Appendix A:  
City Council Resolution Chartering WPWG  
and Waterfront Plan Work Group Schedule

## RESOLUTION NO. 2467

**Waterfront Plan Work Group Updated Meeting Schedule (12.8.2011 Update)**

**QUESTIONS FROM THE WATERFRONT PLAN WORK GROUP  
WITH RESPONSES FROM STAFF (11.9.2011)**

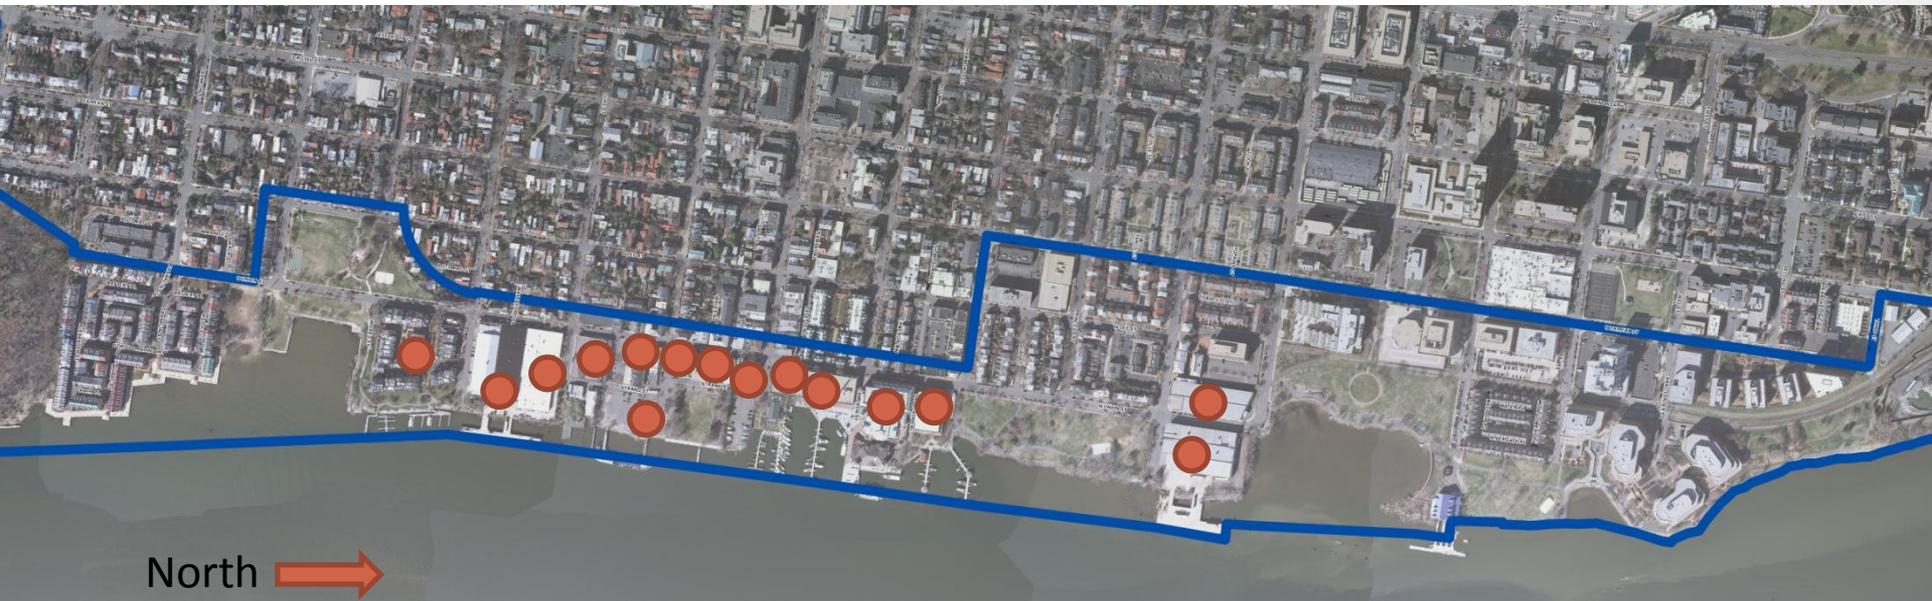
**Question 4: Information and map of existing buildings showing what would not be allowed under the proposed Waterfront Small Area Plan (i.e., The Strand building).**

This material is attached.
